The Land Use Committee (the “Committee”) held a public hearing on September 25, 2018 and working sessions on November 13, 2018, December 11, 2018, and January 15, 2019 on these petitions. This memo reflects additional information received by the Planning Department as of March 7, 2019. A current schedule of meetings on these petitions is also attached (**Attachment A**).

Project Update

Responses to the
November 6, 2018 Horsley Witten Group Peer Review
and
Planning Staff Comments
from
Northland Investment Corporation
February 2019

Re: Site Plan & Open Space Review – *Response to Revision 1*
Northland Newton Development
Mixed Use Development Special Permit Site Plan Review

Northland Newton Development
 Original Proposal
 02.06.19

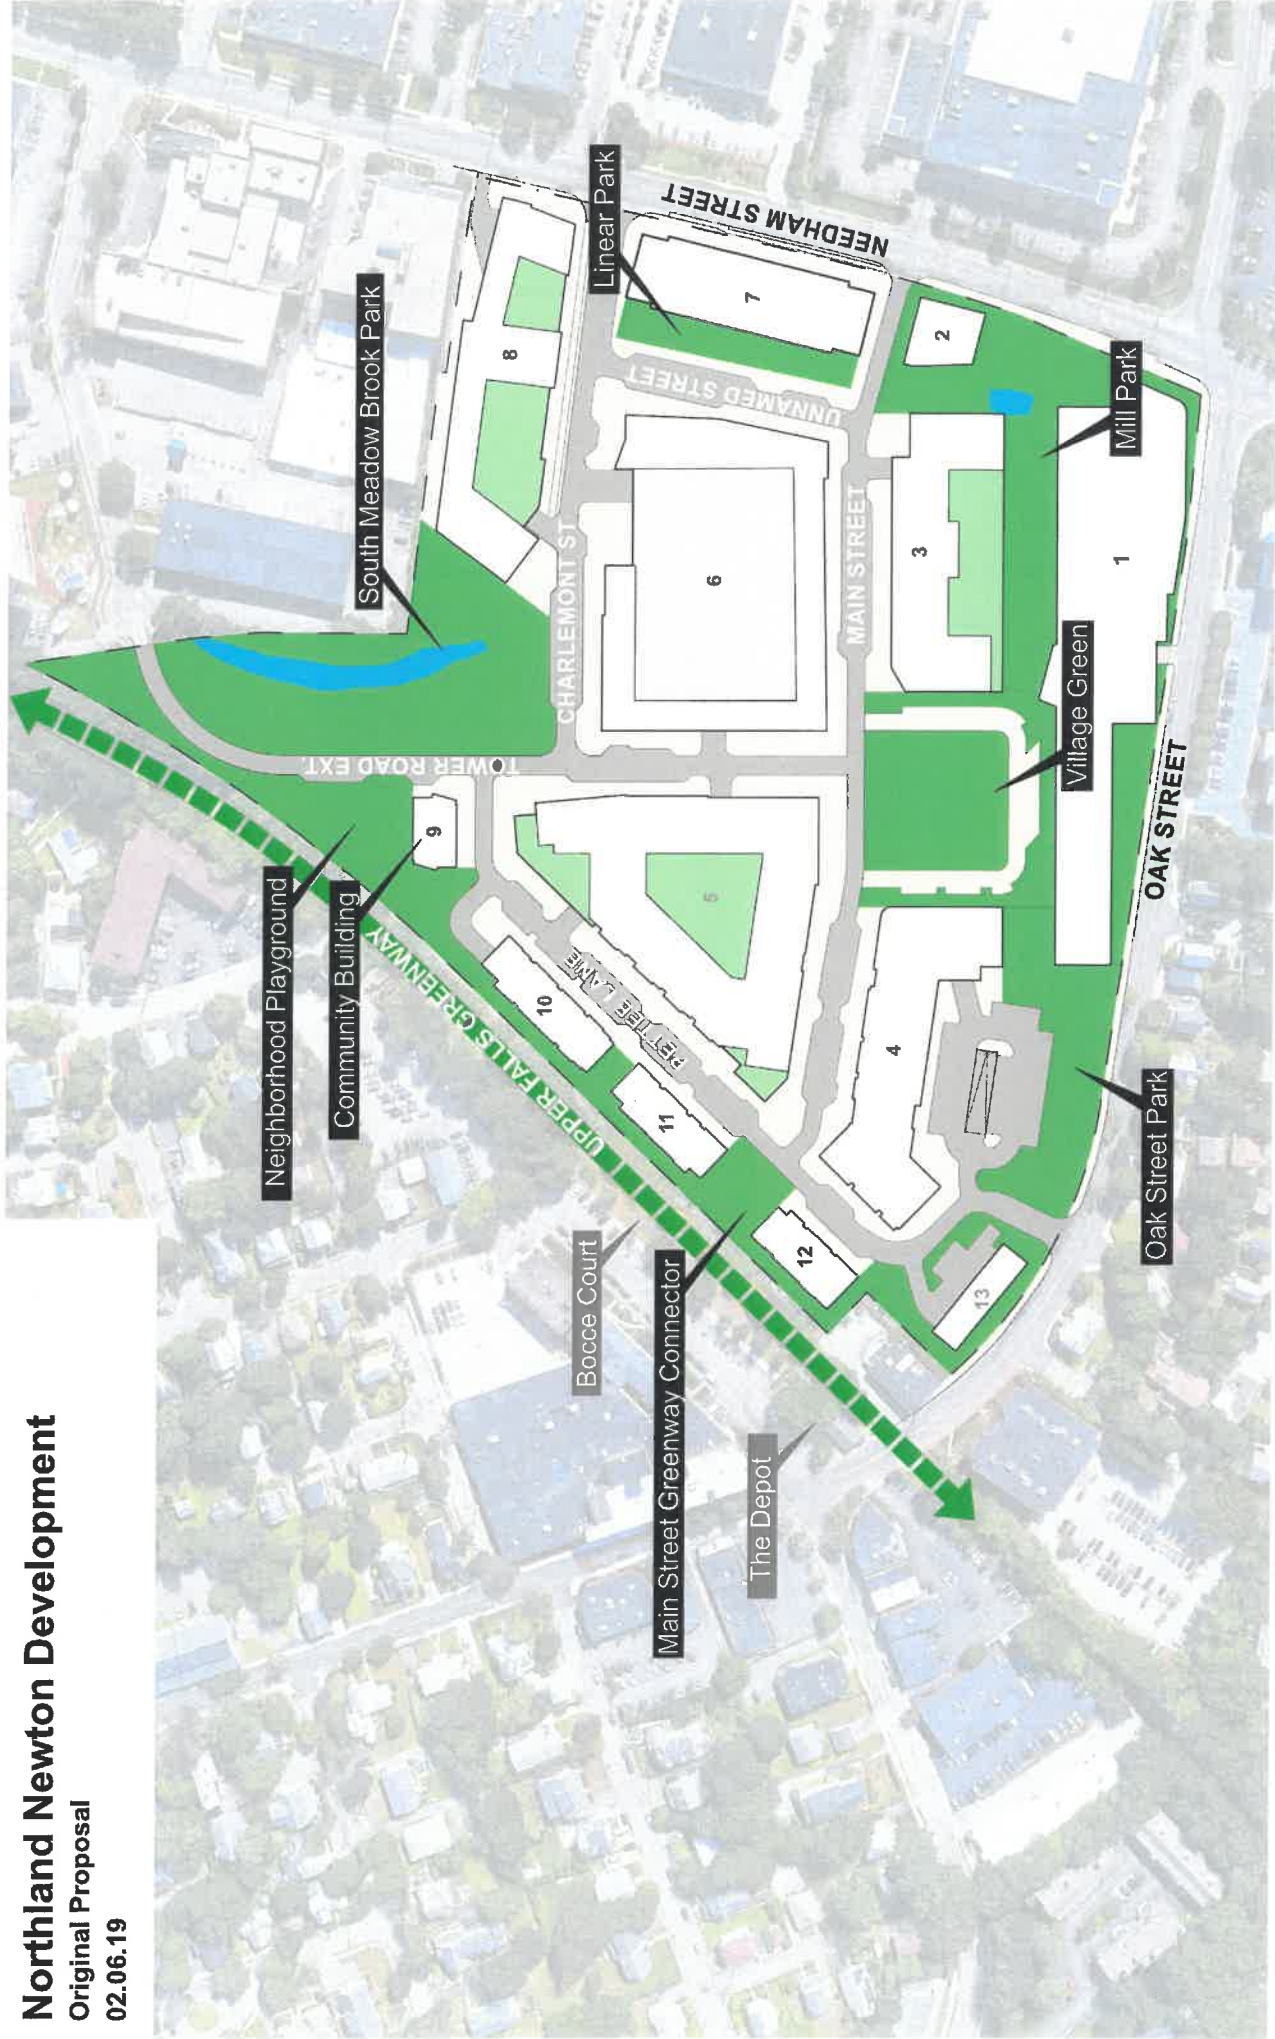
- Buildings 5 and 6 frontages were long, and we should look at breaking them up to provide both E-W and N-S access (Planning, Horsely Witten,

- Building 4 – not enough access to the Oak Street Park (Planning)
- Building 7 – mid-building permeability (Horsely Witten, Councilor Downs, Councilor Kelley, Chairman Schwartz, Councilor Laredo)
- Building 4 – recommended parking underground (Horsely Witten)
- Village Green – width of driveways around 4 sides (Horsely Witten, Urban Design (Dooling), Newton Highlands NAC (Lichtin), Councilor Greenberg, Councilor Downs, Chairman Schwartz)
- Location of Community Building (Planning, Horsely Witten, Newton Highlands NAC (Lichtin), Councilor Greenberg)
- Parking – both the number of parking spaces and the above ground garages in Buildings 5 and 6 were discussed (Horsely Witten, Councilor Auchincloss, Councilor Downs)

Key Plan Refinements

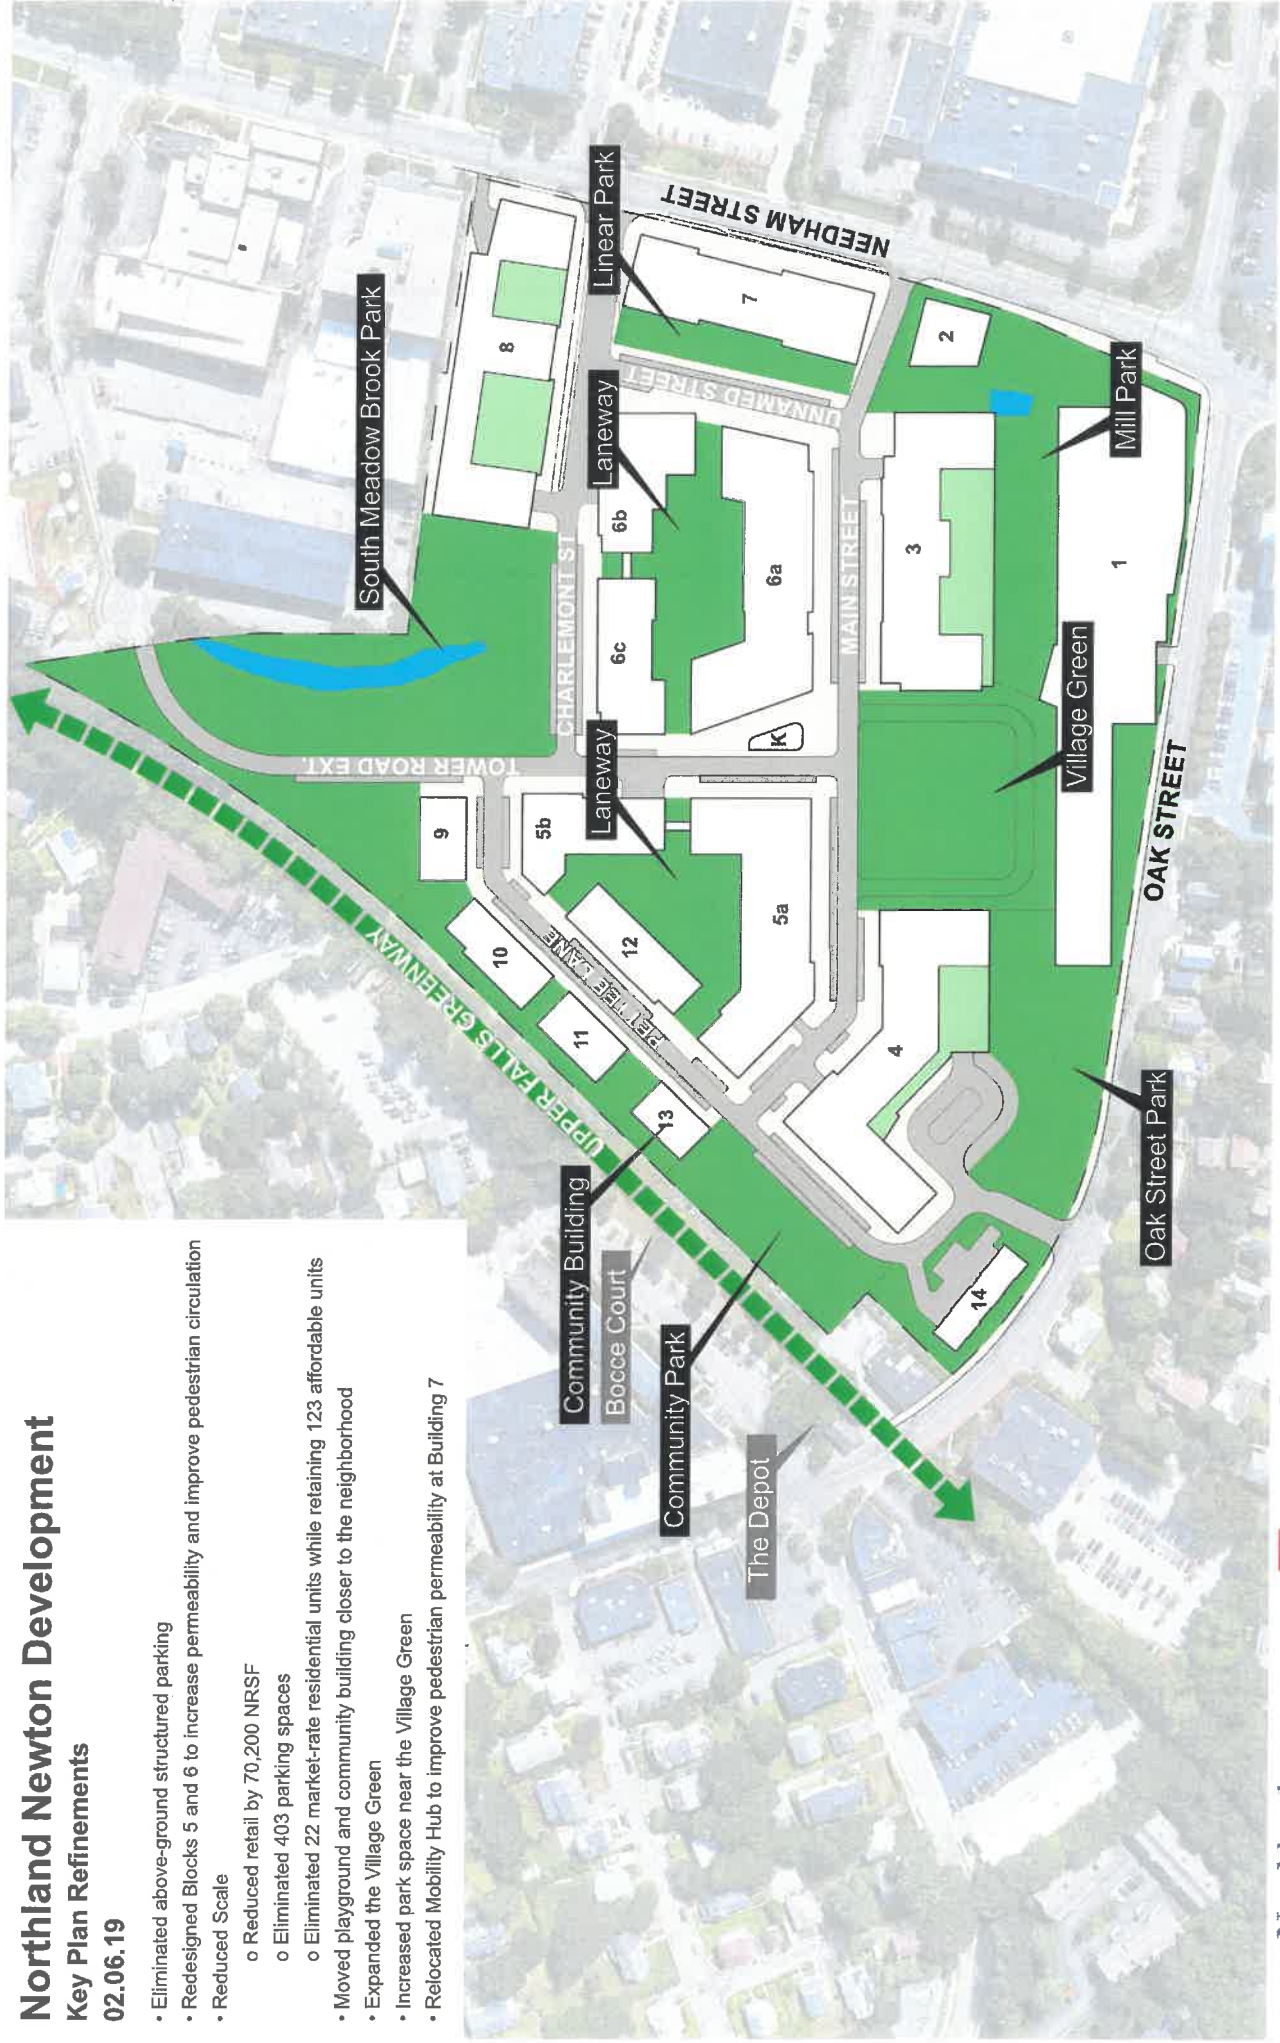
- Parking for Buildings 5 and 6, formerly above grade, has been pushed below grade allowing the massing of these two buildings to be broken down into smaller, individual buildings separated at grade by “residential scaled laneways,” a change that also creates additional open space within these blocks and opportunities for circulation.

- The size of Building 4 and the surface parking lot behind Building 4 have been reduced;
- The total number of parking spaces has been reduced from 1,953 to 1,595;

- The “Mobility Hub” has been relocated to the center of Building 7;
- The Village Green has increased in size as previously proposed parking and general vehicle access along its perimeter has been eliminated;

- The proposal to locate the parking in Buildings 5 and 6 entirely underground results in a dramatic improvement to the massing and permeability of these buildings and presents exciting opportunities for additional open spaces. This change also improves circulation and helps solve the problem of locating typical back of house uses (trash, loading, garage entrances, etc.) in buildings that previously had no back side;
- The revised location of the Mobility Hub helps mitigate concerns that Building 7 would be oriented more towards the interior of the site and ignore Needham Street;
- The increase in open space and relocation of the community building and playground also appear to be positive changes.

- Eliminated above-ground structured parking
- Redesignated Blocks 5 and 6 to increase permeability and improve pedestrian circulation
- Reduced Scale
 - o Reduced retail by 70,200 NRSF
 - o Eliminated 403 parking spaces
 - o Eliminated 22 market-rate residential units while retaining 123 affordable units
- Moved playground and community building closer to the neighborhood
- Expanded the Village Green
- Increased park space near the Village Green
- Relocated Mobility Hub to improve pedestrian permeability at Building 7
